Technical Note TN-823

Introduction of the T2000-A46 Enhanced Signalling Interface for the T203X/40

5th March 2004

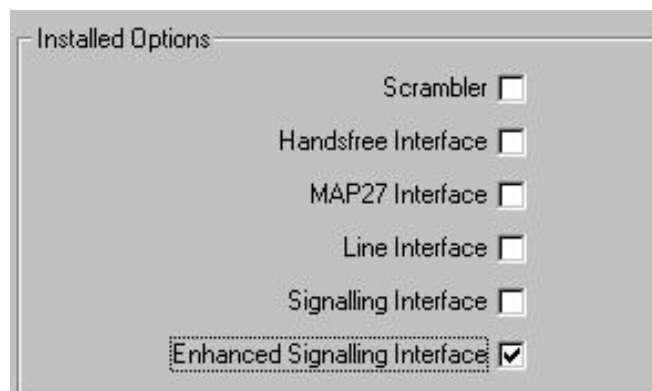
Logic boards with the IPN 220-01344-05 to –12 will need to be modified as follows...

- A link must be fitted between TP602 and pin 17 of #T3K44 (refer to photo below).

- Remove the chip capacitor C516 (0603 100N). This is located near RV507.

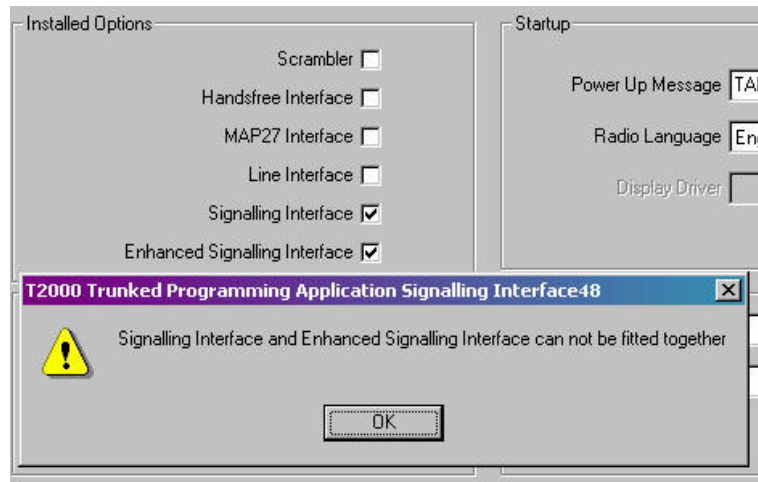
There are two changes to the Trunked Programming Application (TPA). The first is the addition of a field with a tickbox called "Enhanced Signalling Interface" on the *Specifications* page.

The field "Signalling Interface" will still remain so users of the T2000-A4500 can still program their radios. These two fields are mutually exclusive.
